# SUPPORT OF COMMANDER'S INDEPENDENT THERMAL VIEWER (CITV) SOURCE SELECTION

**SUPPORT OF COMMANDER'S  
INDEPENDENT THERMAL VIEWER  
(CITV) SOURCE SELECTION**

**SUBJECT:** Technical Support of Commander's Independent Thermal Viewer (CITV) Source Selection

## COMMENTS ON THE CITV SPECIFICATION

Figure 1: Direct Sunlight Through Vision Block - Top View

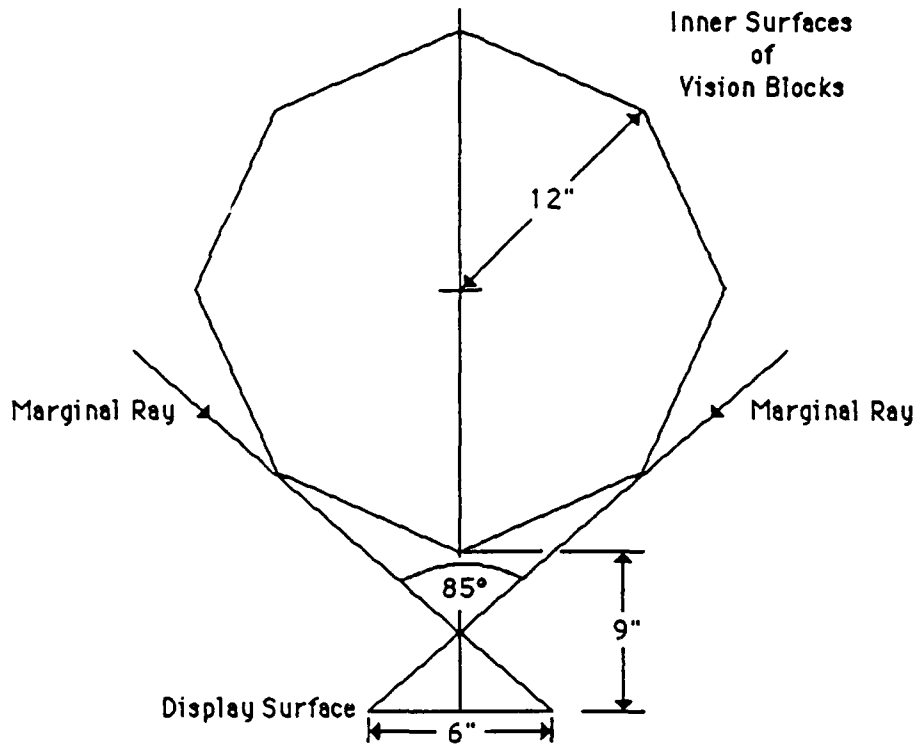
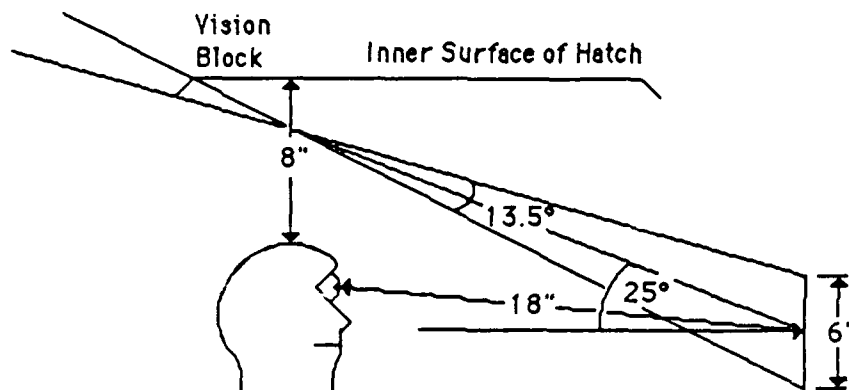
Two figures are attached which show an estimation of the probability of having direct sunlight illuminate the display while the hatches are closed. For Figure 1, it is assumed the turret has equal probability of being in any rotational position with respect to the sun -- accounting for the 360 degrees in the denominator. Of this 360 degrees, only 85 degrees represent a position where the sun could pass via one of the vision blocks and hit the display. This angle represents the angle between the first and last rays to touch the screen and takes into account that the incident beam is not a point. As shown in Figure 2, the angle of incidence is likely to be on the order of 25 degrees with respect to the surface normal -- assuming that the face of the display is vertical. Also, since the rays from the sun are essentially parallel, the size of the beam is the clear aperture of vision block projected onto the display. The angle shown in the side view can be related to the hours during which the sun could shine directly on the display given the season and latitude. Based on the estimates used, it is possible that at the polar regions (greater than 85 degrees latitude), during the summer and on clear days, the sun will be within this angle 24 hours a day. For latitudes below 50 degrees this number is more likely to be on the order of 2-4 hours per day throughout the year.

The sun must be within the 85° azimuth wedge to fall directly on the display.

$$\% \text{probability} = \frac{85^\circ}{360^\circ} \times 100 \approx 24\%$$

- 1) More exact calculations are possible if more accurate information regarding the geometric relationships is made available. This may be essential if the conclusions drawn from the test critically impact operational performance, the display design, and specification. In general, we recommend supplying the display manufacturer

with drawings which show the important geometrical relationships, including the possible positional variation of the commander's eye.

- 2) Full operational performance in direct sunlight can be specified. This option appears to be the least desirable as it requires a significant design (cost) effort to alleviate a problem which will occur very infrequently.

- 3) Acceptable performance (lower than full operational performance) in direct sunlight can be specified.
- 4) Operation in direct sunlight can be requested and costed as an option, with the display manufacturer providing anticipated performance at additional cost.

- 5) Ask the Army to make an operational assessment of these conclusions, and proceed on their recommendation.
- 6) Modify the ICWS vision blocks to include flaps which can be readily open or closed. This has the added advantage of allowing secure operation with the lights on inside the turret or with a reasonable brightness on the display. This option is beyond the scope of the CID; however, it eliminates an intermittent but significant problem, probably creates only a minor operational annoyance, and can be accomplished with minimal design effort.
